Flight Procedure Tracking Form		Action: FLIGHT CHECK	Task Type: SID	Date Open: 01/16/2013	Task #: 2013011624932201002	Request #: 20130116249322
Procedure: SID JUNEAU FOUR JUNEAU AK PAJN			Airport ID: PAJN	Airport: JUNEAU INTL		Reimbursable #:
City: JUNEAU		ST: AK	GPS #:	Estimated Chart Date: 06/27/2013		FICO #:
Fac ID:	Fac. Type: <i>Proc T</i>		Specialist: VICTOR NASO

JUNEAU, AK JUNEAU INTL (PAJN) JUNEAU FOUR (SID) ENROUTE-NO FC: 5.14.13 PUB: 6.27.13

JUNEAU FOUR DEPARTURE

JUNEAU INTL (JNU)(PAJN)

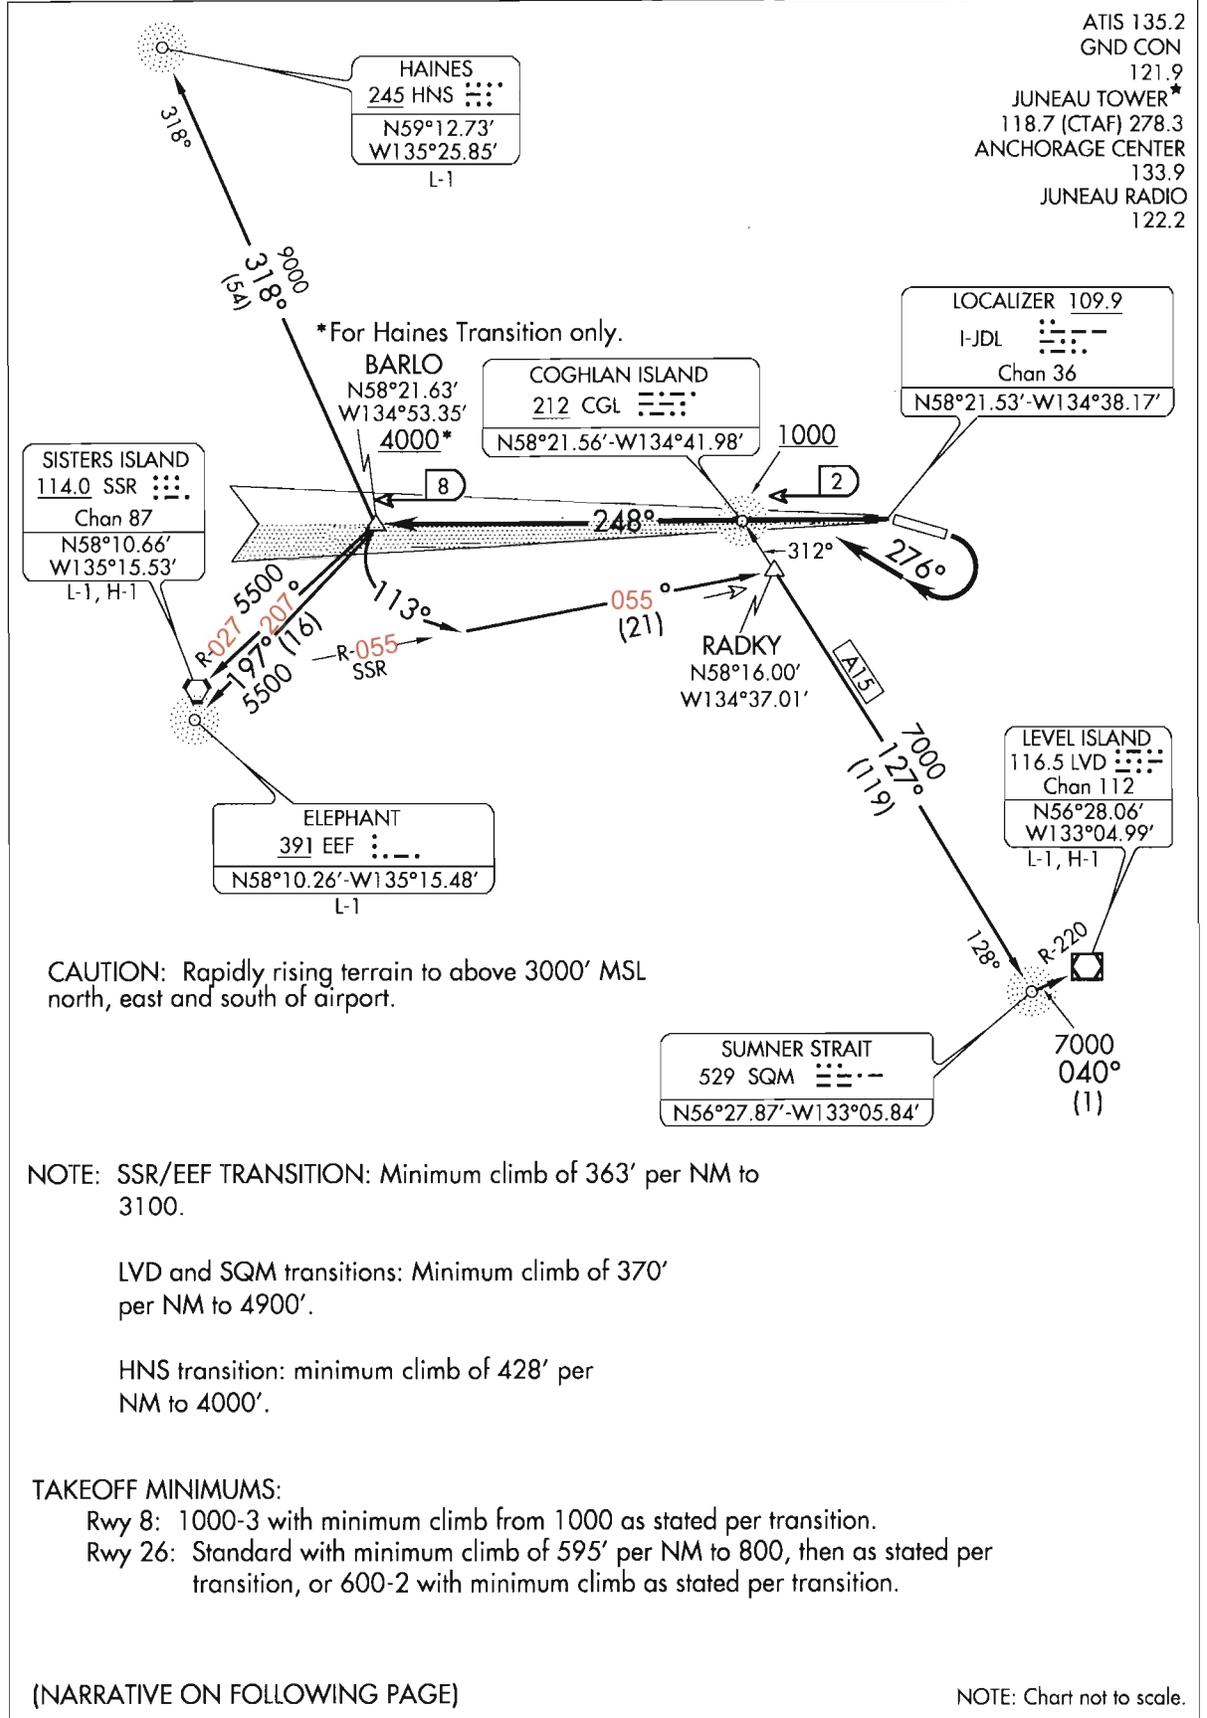
NOTAM CONFIRMATION	
Draft Details	
<p>VICTOR NASO AVN-130 (405)954-5181 01/14/13</p> <p>To: USNOF</p> <p style="text-align: center;">FDC 3/NNNN PAJN JNU FI/T SID JUNEAU INTL, JUNEAU, AK, JUNEAU FOUR DEPARTURE</p> <p>CHANGE SSR VORTAC FIX INTERSECTION CROSSING RADIALS AT: RADKY FROM R-046 TO R-055, BARLO FROM R-018 TO R-027. CHANGE HEADING: BARLO TO SSR VORTAC FROM 198 TO 207, BARLO TO RADKI FROM 046 TO 055. SSR VORTAC MAGVAR UPDATE FROM 29E TO 20E.</p> <p>REASON: THIS NOTAM IS TO ALLOW FLIGHT CHECK TO FLY/VERIFY THE MAGVAR ROTATION FOR AN EARLIER CHART CYCLE. SINCE ALL SE ALASKA WILL BE ROTATING IN 2 CHART CYCLES SOME OF SOME OF THE NAVAIDS COVER MORE THAN ONE AIRPORT AND ROTATE BEFORE THAT AIRPORT. AS AGREED BETWEEN FLIGHT CHECK, AERONAV SERVICES, AWO, FLIGHT STANDARDS, AS AN INTERM FIX NOTAMS WOULD BE PUBLISHED FOR THOSE PROCEDURES 6/27 AND THEN CANCELLED THE FOLLOWING CHART CYCLE 8/22 WHEN THE AIRPORTS PUBLISHED. THIS WILL ALLOW FLIGHT CHECK TO VERIFY THE MAGVAR ROTATION 1 CYCLE EARLY.</p> <p>DEBORAH COPELAND MANAGER, AVN-130</p> <p>CC: AVN-101 AVN-130 FPO WST</p> <p>ADDITIONAL COMMENTS:</p>
